## MEMORANDUM

To: Parks and Recreation Board

From: Jesus M. Olivares, Director  
Parks and Recreation Department

Subject: Construction of Bentzin Boat dock at 4603 – 4511 Island Cove  
File No. SP-99-2197DS.

SITE PLAN

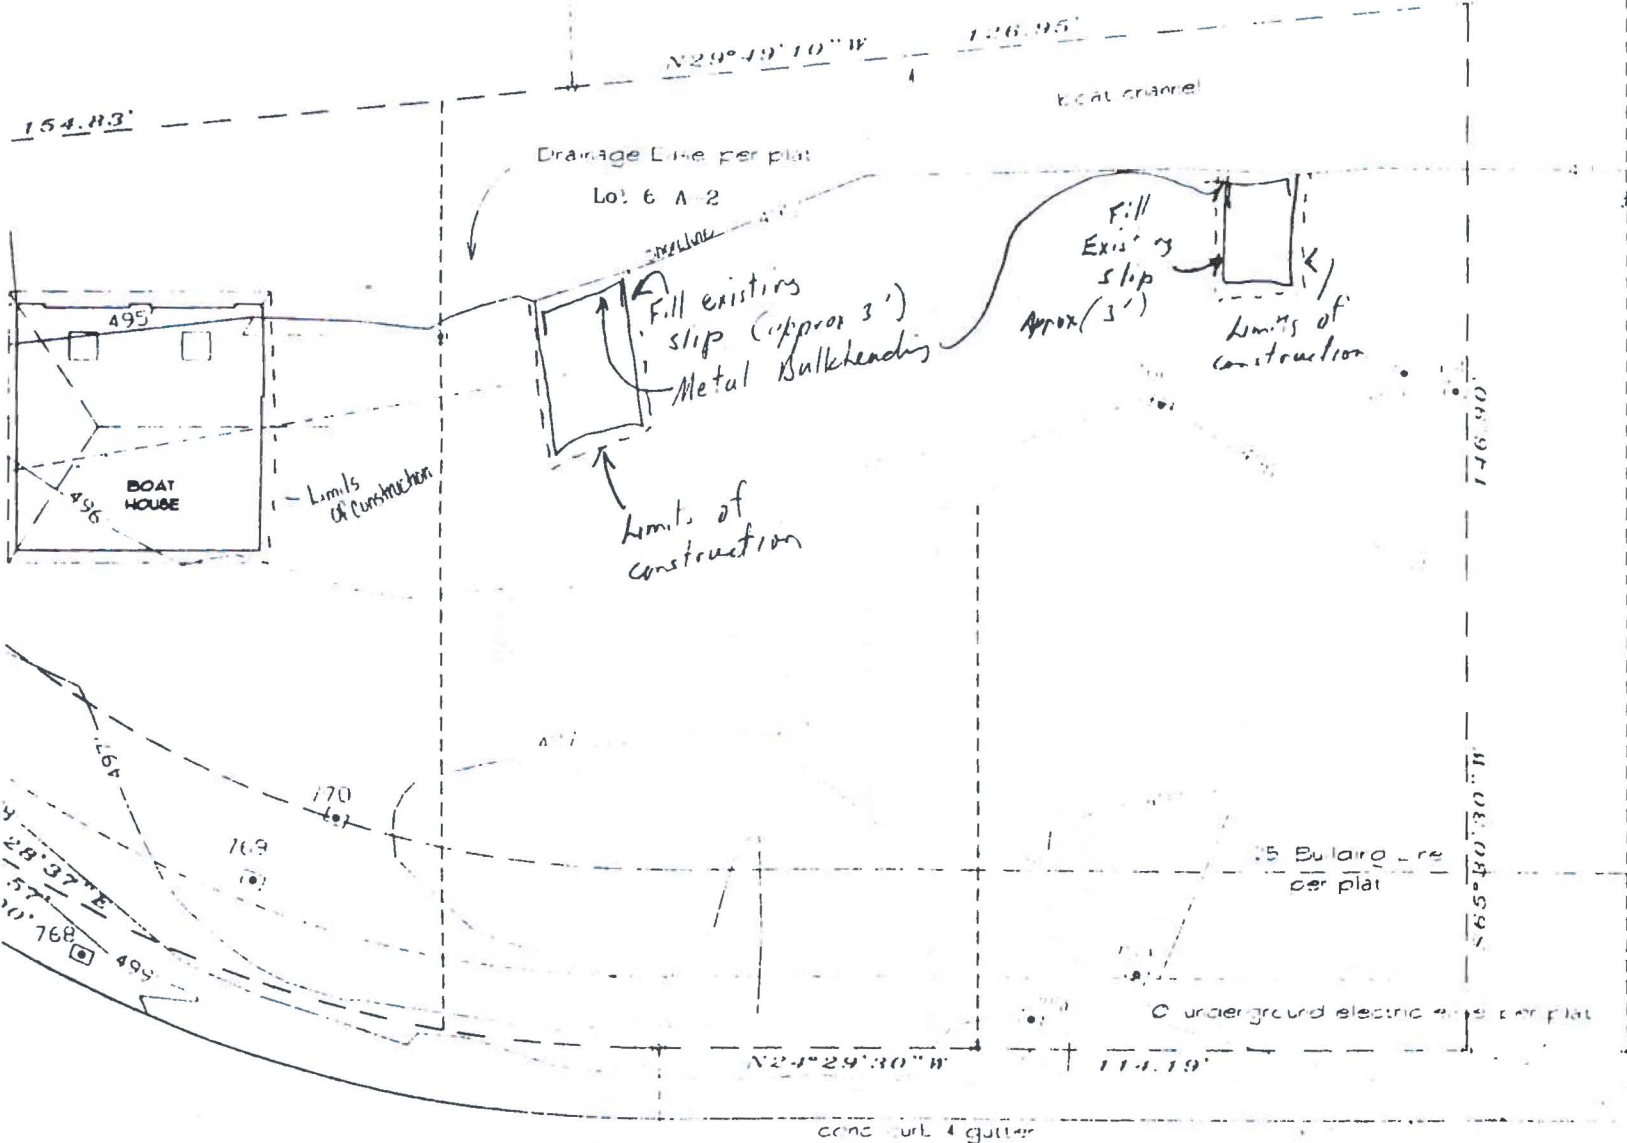
The Parks and Recreation Department (PARC) staff has reviewed plans for the proposed boat dock and finds they meet the requirements of Article VI, Part E, (Requirements for the Construction of Boat Docks) of the Land Development Code.

Discharge of fill material into water of the United States requires a Section 404 Permit of the Clean Water Act. Therefore, a 404 permit must be obtained from the U.S. Army Corps of Engineers before the filling of the two existing slips.

I recommend approval of the above request as detailed in the attached site plan.

### UPPER LEVEL PLAN

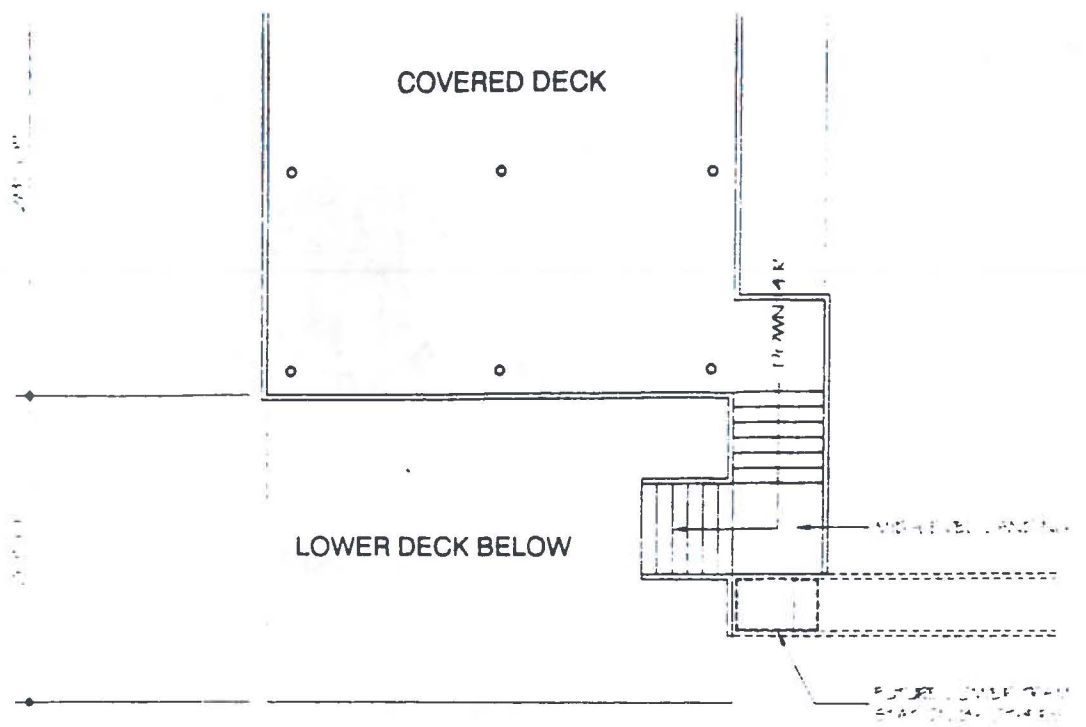
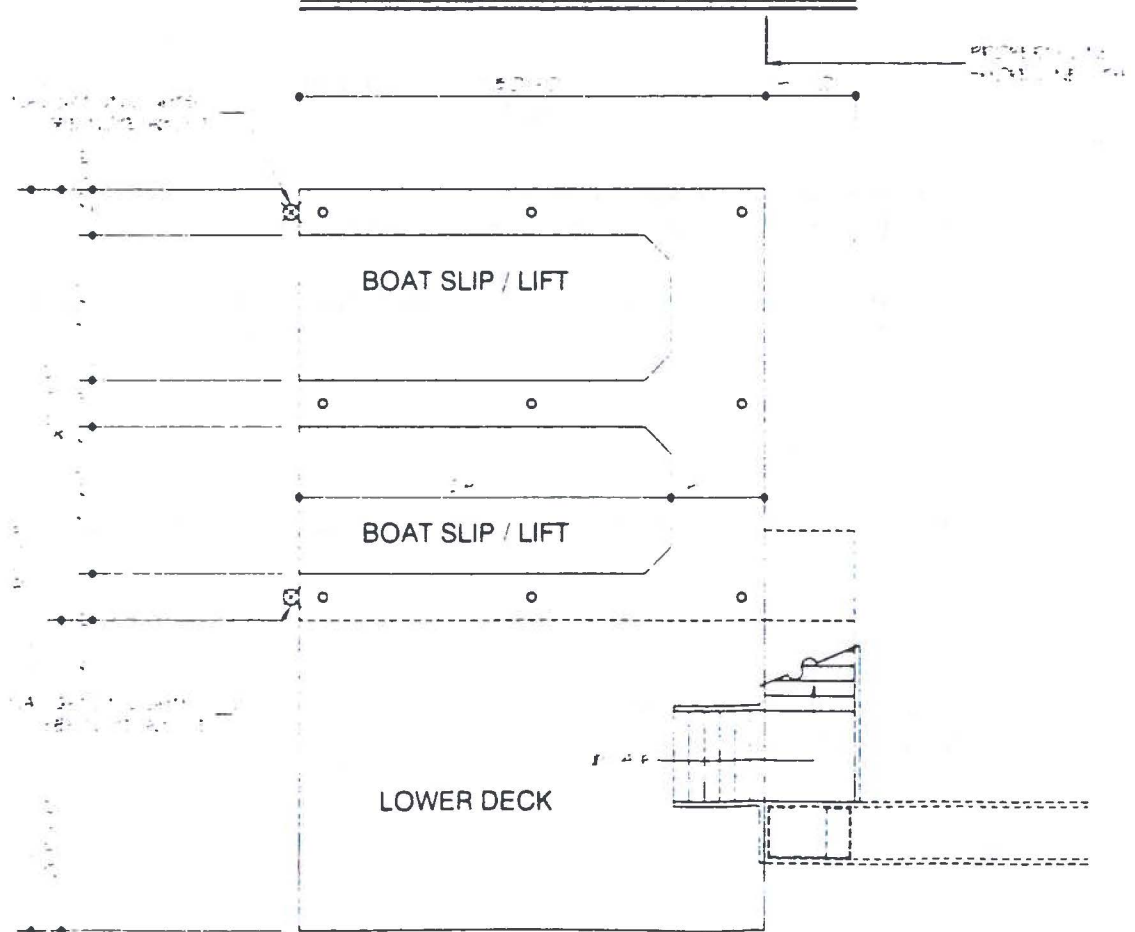
The Parks and Recreation Department (PARD) staff has reviewed plans for the proposed project and finds they meet the requirements of Article VI, Part E, (Requirements for the Construction of Boat Docks) of the Land Development Code.

I recommend approval of the above request as detailed in the attached site plan.

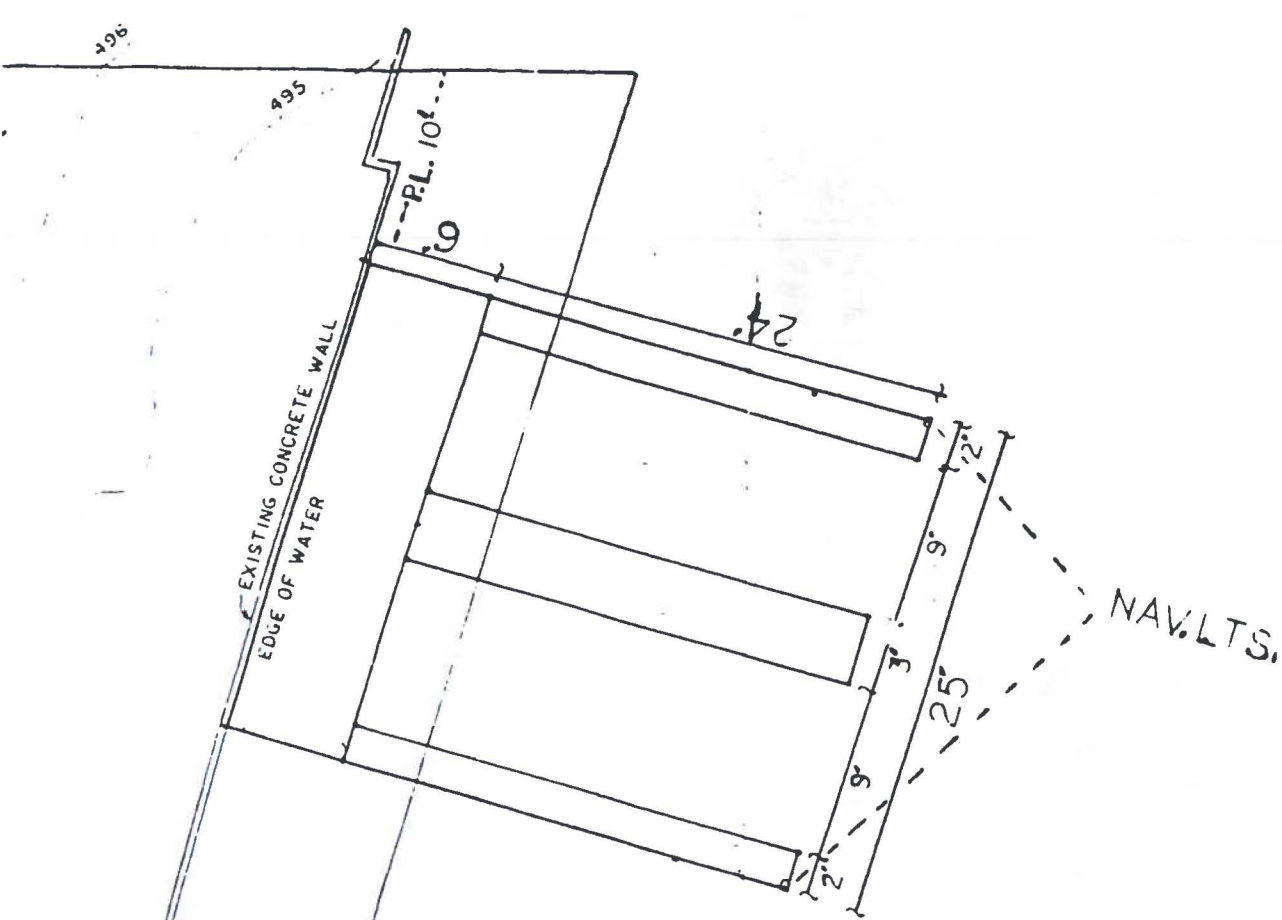
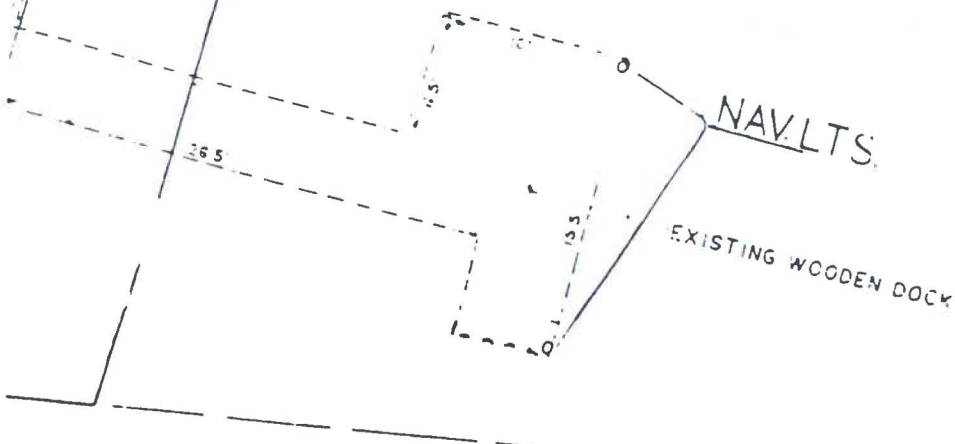
The Parks and Recreation Department (PARC) staff has reviewed plans for the proposed project and finds they do not meet the requirements of Article XIII, Section 25-2-1176, (Regulations for the Construction of Boat Docks) of the Land Development Code. The proposed docks exceed 20 percent of the shoreline width of the land on which the structure is to be constructed.

I am requesting a variance from the 20% frontage limitation in order to construct a boat dock at my home. The variance is justified for the following reasons:

I do not recommend approval of the above request as detailed in the attached site plan.

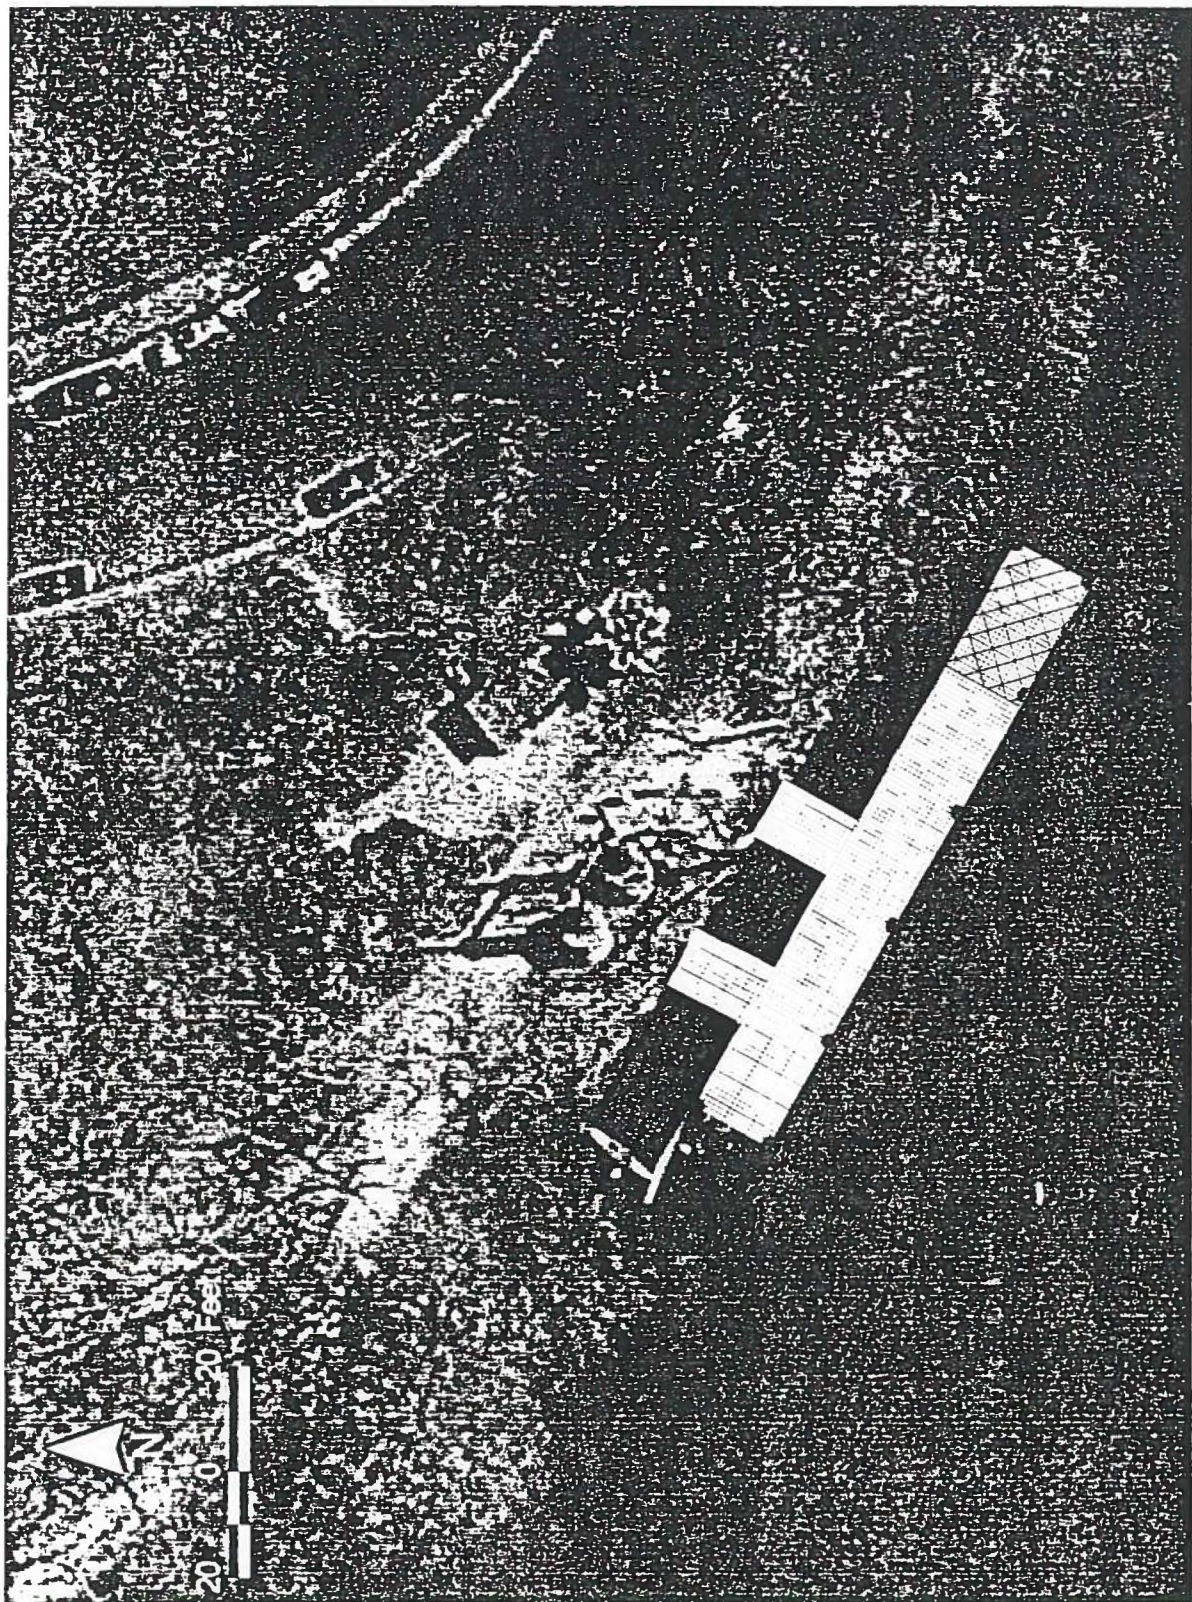
As you know, Texas Rowing Center has requested approval from the Parks and Recreation Department to expand and replace our dock. This letter clarifies our dock expansion plan. Attached is a copy of an aerial photograph with a superimposed image of the proposed dock as expanded. The scale in the upper-left corner is accurate and each grid square represents one square foot. The diagonally shaded area indicates where the additional dock length will be added.

The expanded dock will be 120 feet long and 16 feet wide. It will be constructed of six 20 by 16 foot sections attached end to end by hinges. The new dock's wooden construction will be similar to the dock constructed by the Austin Rowing Club. The dock will have electric lights at each of the four corners. In addition, four lights will be placed on the waterside edge of the dock at 20 foot intervals (there will be a total of nine lights, seven will be on the waterside edge). The lights are indicated as red dots in the attachment. The new dock will be approximately eight feet further from the shore than the current dock, but no part of the dock will be more than thirty feet from the shore. This alteration will allow us to utilize two sides of the dock for boat docking.

The new dock will be anchored to the shore using two 16 foot by 12 foot ramps. The two ramps will be placed 20 feet apart. Each ramp will be hinged to the dock and hinged to the shore using two steel rods driven several feet into the ground. This "double-hinge" arrangement will allow the dock to rise and fall with the river.

I recommend approval of the above request as detailed in the attached site plan.

Floating Dock

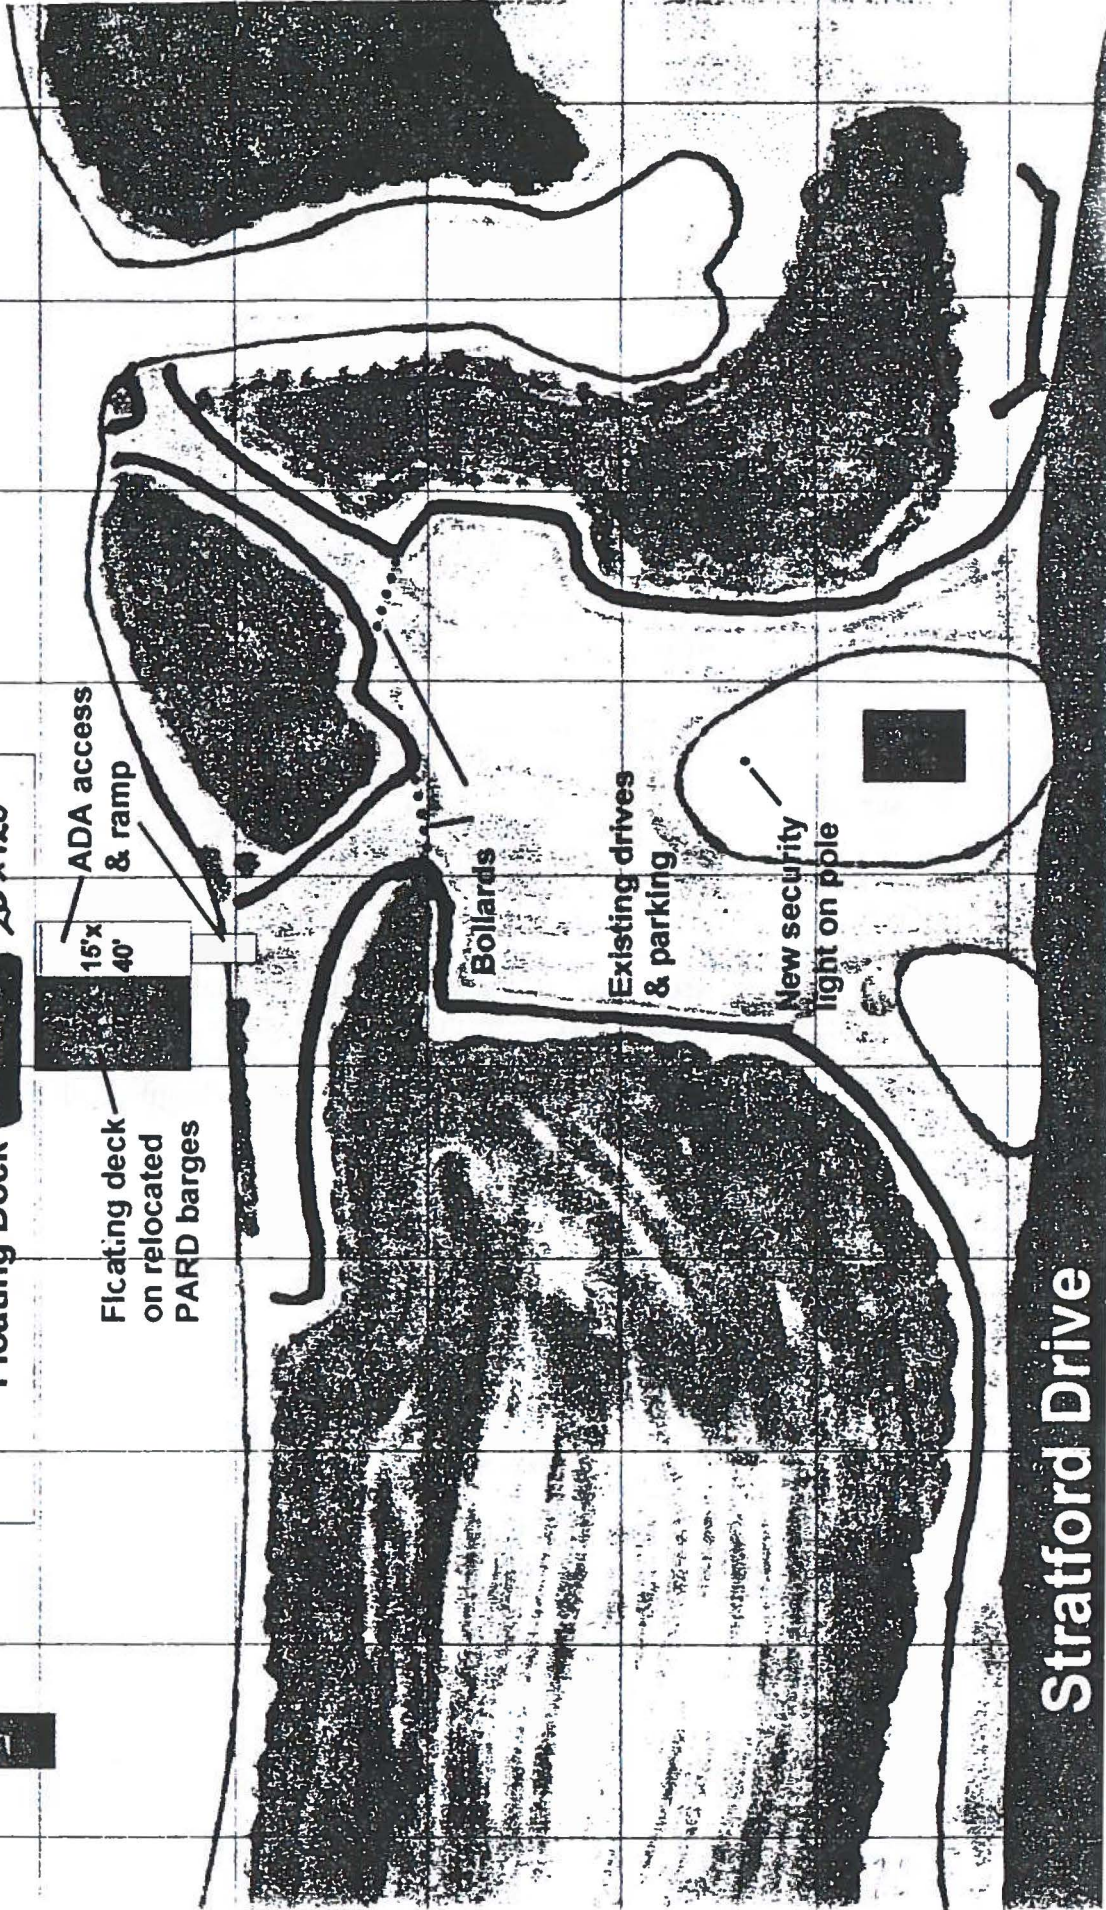
The Parks and Recreation Department (PARD) staff has reviewed plans for the proposed project and finds they meet the requirements of Article VI, Part E, (Requirements for the Construction of Boat Docks) of the Land Development Code. The staff has recommended that the dock be a maximum of 120' in length parallel to the shoreline.

I recommend approval of the above request with staff recommendations.
